Access Compliance Report

(Curb Ramps)

Intersection ID: 2927	Main Street: DOWNFIELD_WOOD_DR	Cross Street: RIDGEFIELD_DR	Location: NW
ADA ID: A0C6062CFC61	Ramp Type: Perp	Initial Pass/Fail: Fail	Overall Compliance: No
Codes/Mitigation Info/Possible Solution		Field Measurements/Component Compliance	
Severity Score: 8.75

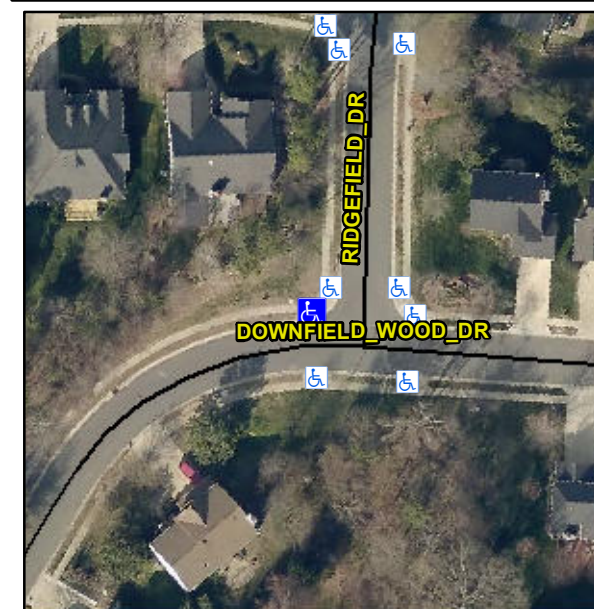
R304.5.1

Compliance	Description	Data	Compliance	Description	Data
N/A	Ramp Length (in)	47.0	Yes	Ramp Slope (%)	8.1
No	Ramp Width (in)	40.5	Yes	Ramp XSlope (%)	1.1
N/A	Flare Type LT	N/A	N/A	Flare Type RT	N/A
N/A	Flare Slope LT (%)	N/A	N/A	Flare Slope RT (%)	N/A
N/A	Flare Traversable LT?	N/A	N/A	Flare Traversable RT?	N/A
N/A	Landing Length (in)	N/A	N/A	DWS Provided?	N/A
N/A	Landing Width (in)	N/A	N/A	DWS Contrast?	N/A
N/A	Landing Slope (%)	N/A	N/A	DWS Length (in)	N/A
N/A	Landing X Slope (%)	N/A	N/A	DWS Full Width?	N/A
N/A	Landing Curb? (Y/N)	N/A	N/A	DWS Offset (in)	N/A
N/A	Shared Landing?	N/A			
N/A	Gutter Ponding?	N/A	N/A	Gutter Slope (%)	N/A
N/A	Gutter Lip Ht (in)	N/A	N/A	Gutter X Slope (%)	N/A
N/A	Painted X Walk1?	No	N/A	Painted X Walk2?	N/A
	X Walk 1 Direction	To S		X Walk 2 Direction	N/A
N/A	X Walk 1 Width (in)	N/A	N/A	X Walk 2 Width (in)	N/A
	X Walk 1 Slope (%)	3.6		X Walk 2 Slope (%)	N/A
	X Walk 1 X Slope (%)	2.3		X Walk 2 X Slope (%)	N/A

Remove & Replace Entire Ramp.
